Federal Motor Vehicle Safety Standards; School Bus Body Joint Strength

ACTION: Final rule; response to petitions for reconsideration.

SUMMARY: On November 5, 1998, NHTSA published a final rule that amended Federal Motor Vehicle Safety Standard No. 221, *School Bus Body Joint Strength*, with an effective date of May 5, 2000 for those amendments. The amendments extended the applicability of that standard to small school buses, narrowed the exclusion of maintenance access panels from the joint strength requirements, and made other changes to the standard. We delayed the effective date on two occasions, so that we would have time to analyze petitions for reconsideration. First, in a final rule published on March 6, 2000, we delayed the effective date to May 5, 2001, and corrected a typographical error. Second, in a final rule published on April 20, 2001, we delayed the effective date to June 1, 2002. We have now completed our analysis of the petitions, and are taking the following actions: making it clearer that the standard applies to small, curved and complex joints; excluding joints that are forward of the passenger component; and making various other changes to the standard. For

FIGURE 1

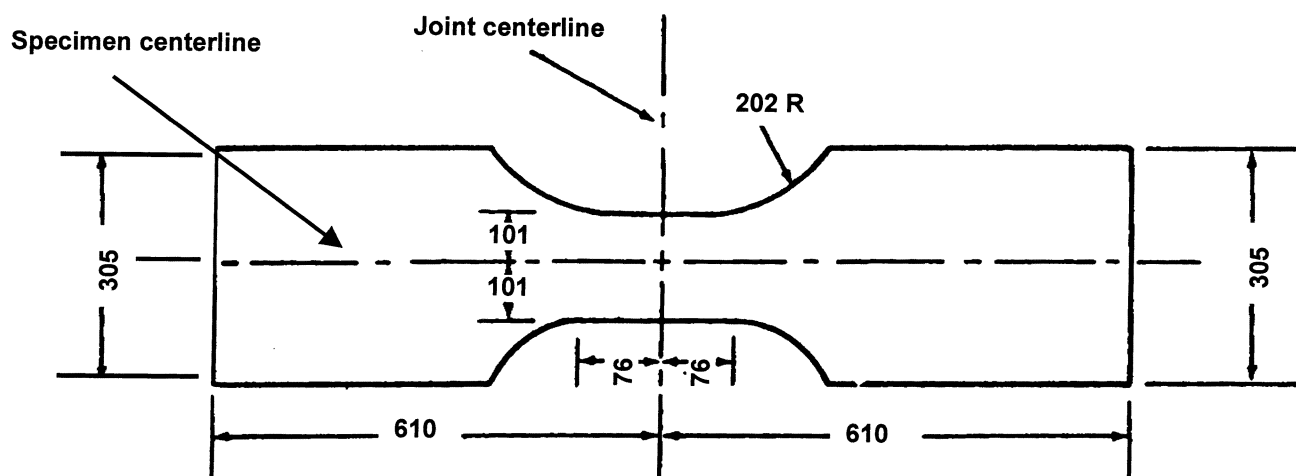
Blue Bird also stated that if curved and/or complex joints are addressed in Standard No. 221, definitions must be provided, or Figure 1 must show side and end views of the specimen with tolerances on critical dimensions. NHTSA agrees that if there are any unclear or unresolved areas in Standard No. 221, they should be addressed by notice and comment rulemaking, where the public will have an opportunity to present its views.

3. Figure 1 is revised to read as follows:

S6.3.2 Adjust the testing machine grips so that the applied force on the joint is at 90 degrees plus or minus 3 degrees from the joint centerline, as shown in Figure 1.
